Tennessee Valley Authority, 1101 Market Street, LP 5A, Chattanooga, Tennessee 37402-2801

August 8, 2008

Docket Numbers 52-014 and 52-015

**BELLEFONTE COMBINED LICENSE APPLICATION – RESPONSE TO
ENVIRONMENTAL REPORT REQUEST FOR ADDITIONAL INFORMATION -
HYDROLOGY**

Figure 5.2-X1
Water Temperature Sampling Location Map

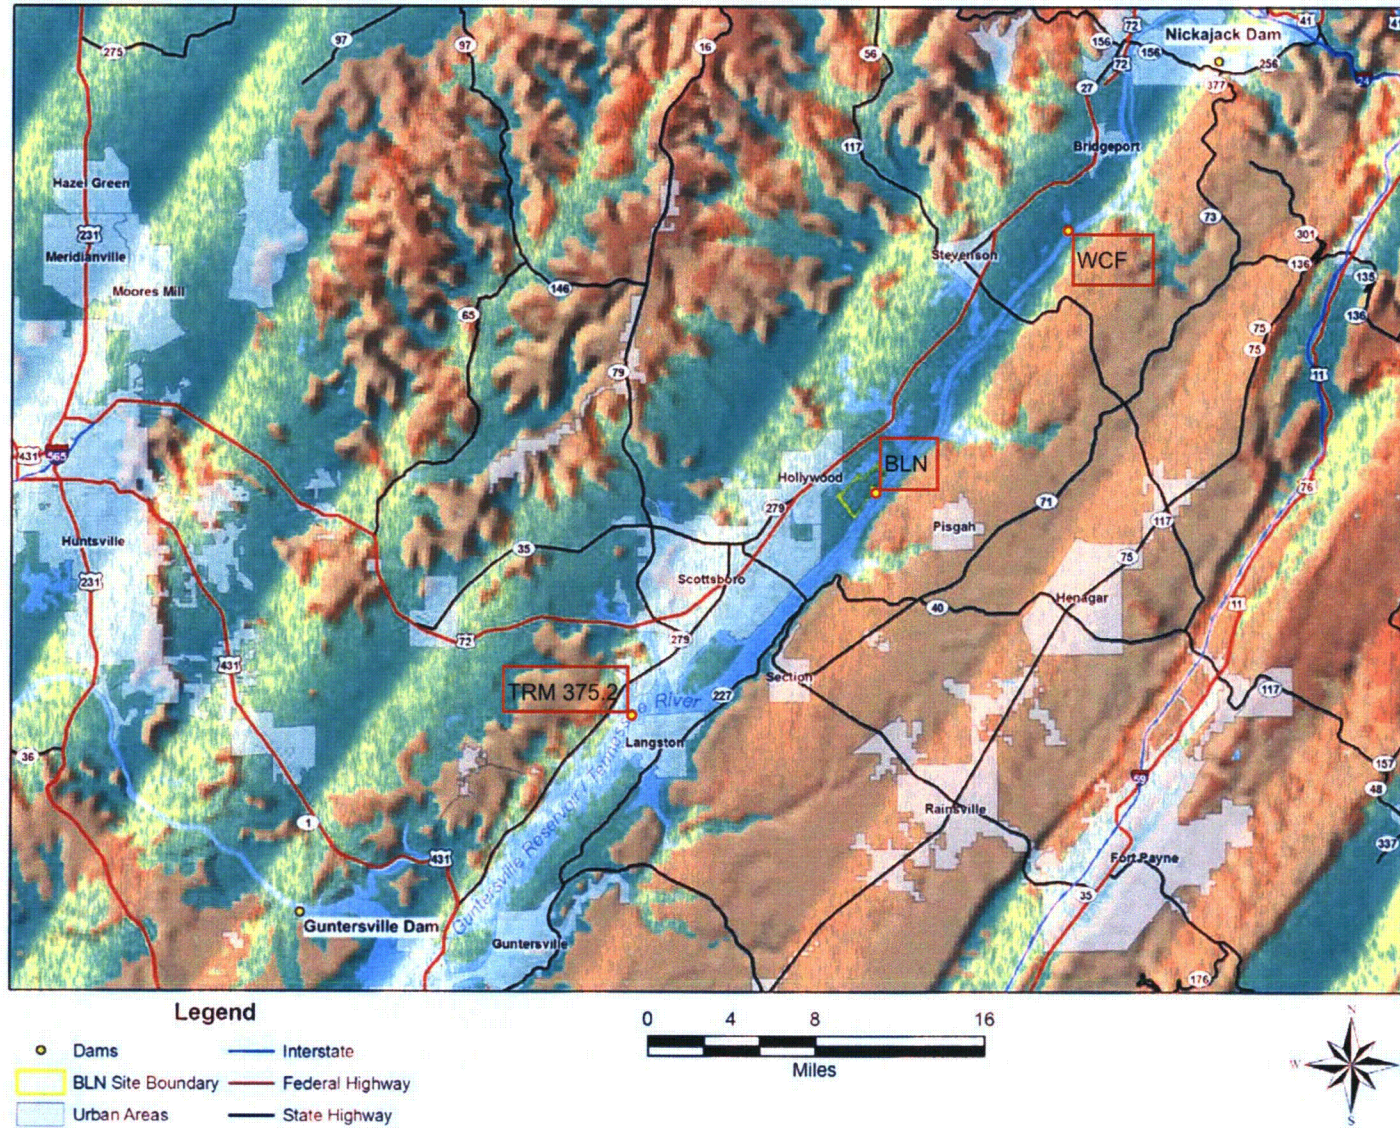
Describe the origin, measurement methods, instrumentation, etc., for the temperature data collected from 1974 to 1990. Provide the data.

Are there data from the Widows Creek facility, upriver of Bellefonte, on temperature of Guntersville Reservoir in the vicinity? If available, provide these data.

Widows Creek Fossil Plant (WCF) records daily temperature readings at the H-6 intake, located at TRM 407.0, at an approximate depth of 20 feet below surface. As part of the Vital Signs monitoring program, TVA collects temperature data at various depths at three points on the Tennessee River in the Bellefonte region between the months of April and October. The nearest downstream location is at TRM 375.2, where temperature data is collected at depths between 1 foot and approximately 36 feet below the surface. These two long-term temperature monitoring stations (WCF and TRM 375.2) bracket the BLN site, which is situated between approximately TRM 391 and TRM 394, as shown in Attachment 5.2-4B. ER Section 5.2 is revised to include Attachment 5.2-4B as a new figure (currently designated as Figure 5.2-X1).

2. Change COLA Part 3, ER Chapter 5, by inserting **Figure 5.2-X1** (provided as Attachment 5.2-4B to this enclosure), Water Temperature Sampling Location Map, in the appropriate location near the end of the chapter.
3. Change COLA Part 3, ER Chapter 5, by adding **Table 5.2-X1** and **Table 5.2-X2**, as follows:

Figure 1 Tennessee River Cross Section Location

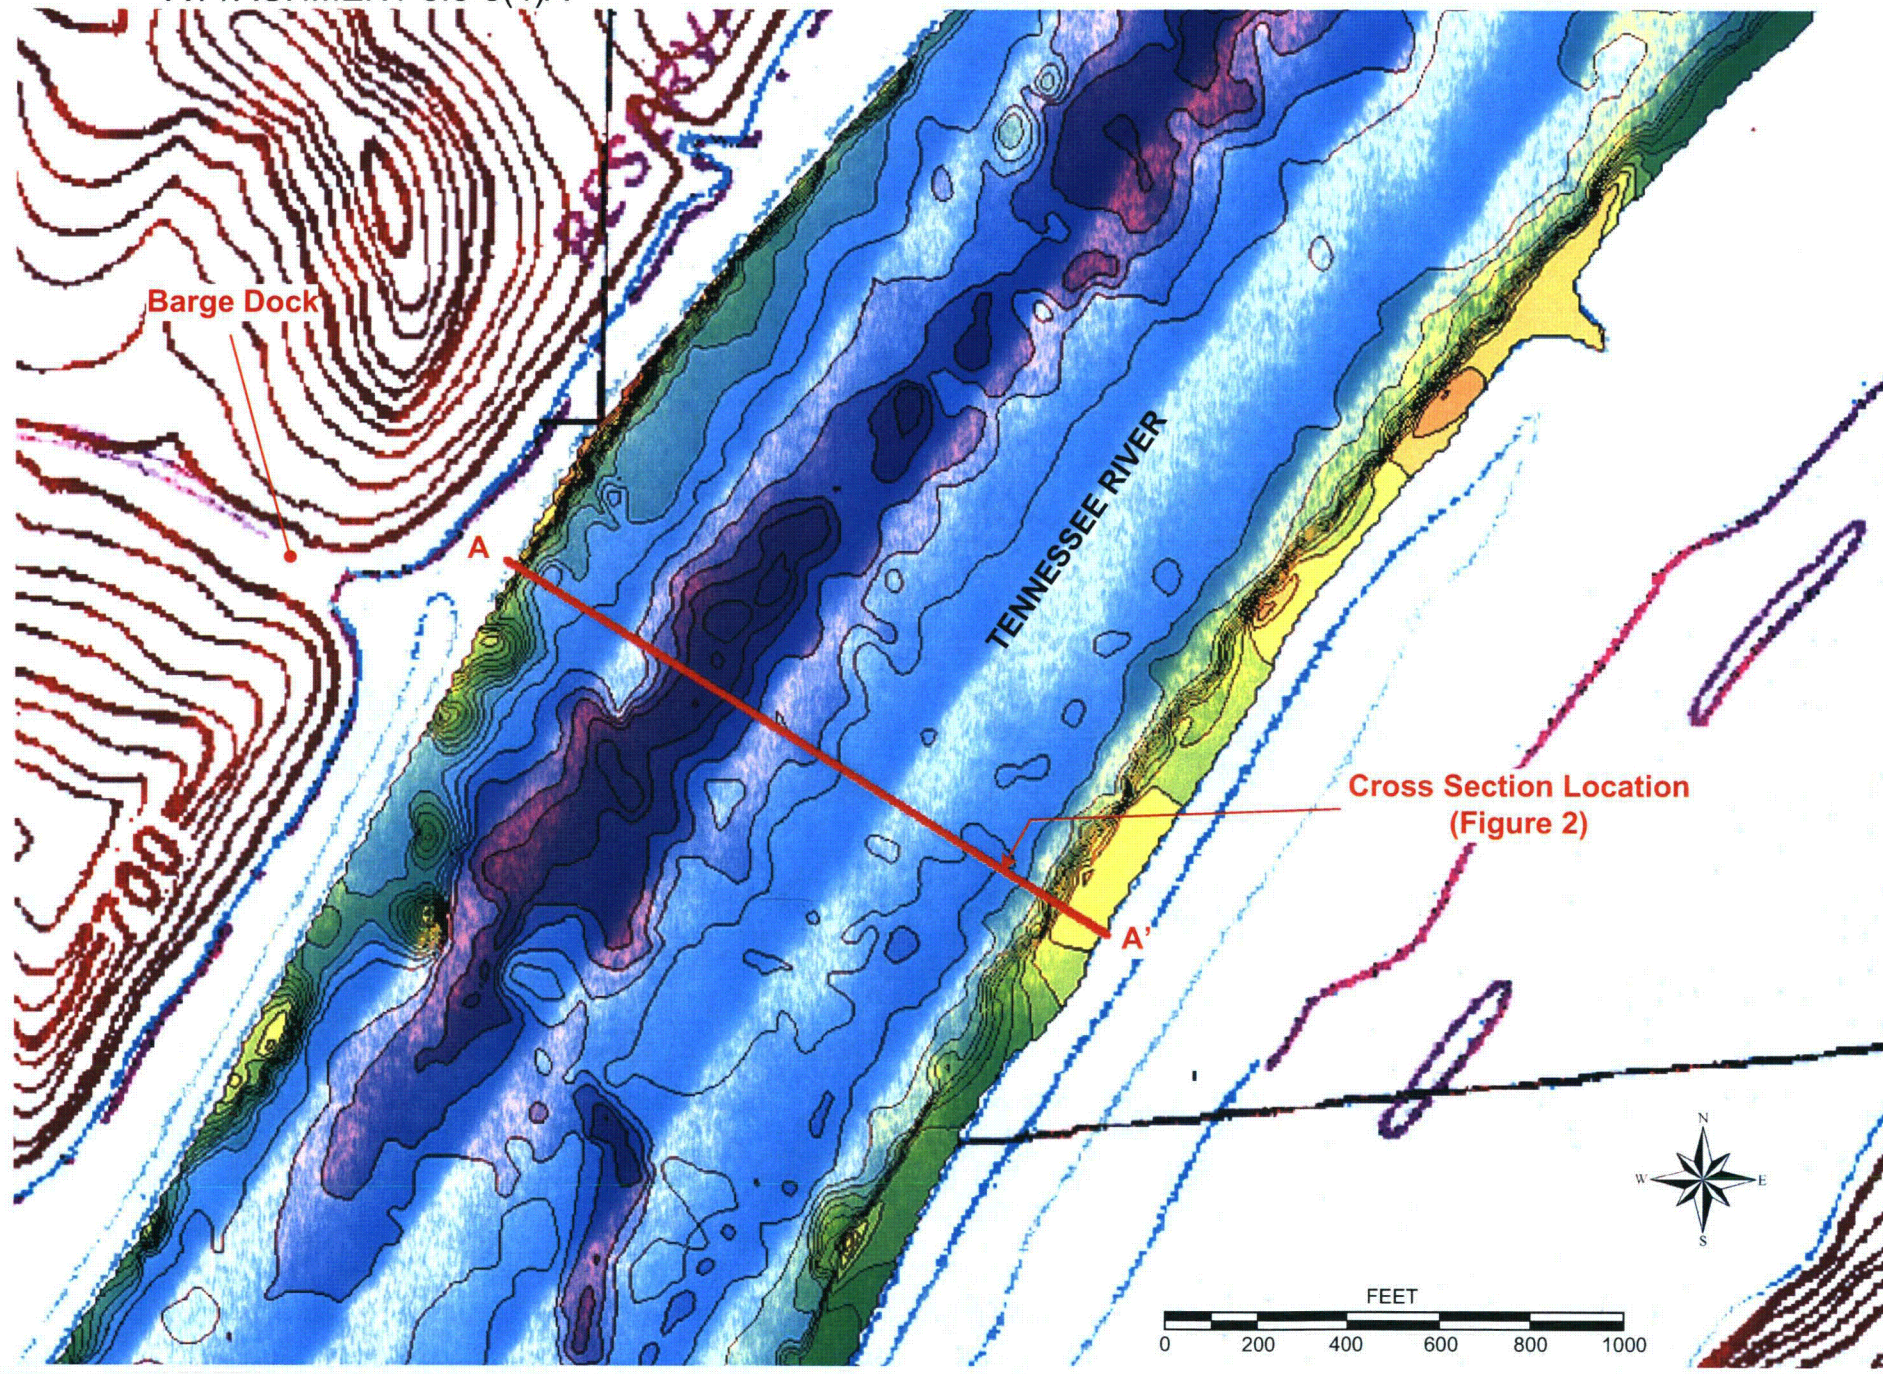
Provide an analysis of the potential for discharge from the diffuser to re-enter the intake canal and be drawn back into the proposed facility. Also analyze the potential for discharge to be drawn into Town Creek.

The discharge diffuser is located approximately 4800 feet downstream (towards Guntersville Dam) of the intake channel inlet and approximately 9400 feet from the confluence of Town Creek and the Tennessee River (Guntersville Reservoir). In order to determine flow velocity of the Guntersville Reservoir, a cross-sectional area of the river channel near the discharge diffuser was developed from the data obtained during the September 2006 bathymetric survey. The location of the cross-section is depicted in Attachment 5.3-3(4)A, and the channel cross-section is shown in Attachment 5.3-3(4)B. The flow velocity (in feet per second) was then calculated by dividing the flow rate (in cubic feet per second [cfs]) by the cross-sectional area (in square feet [ft²]). The flow velocity was calculated for each hour of the reversal and considered as a linear function between hourly data points.
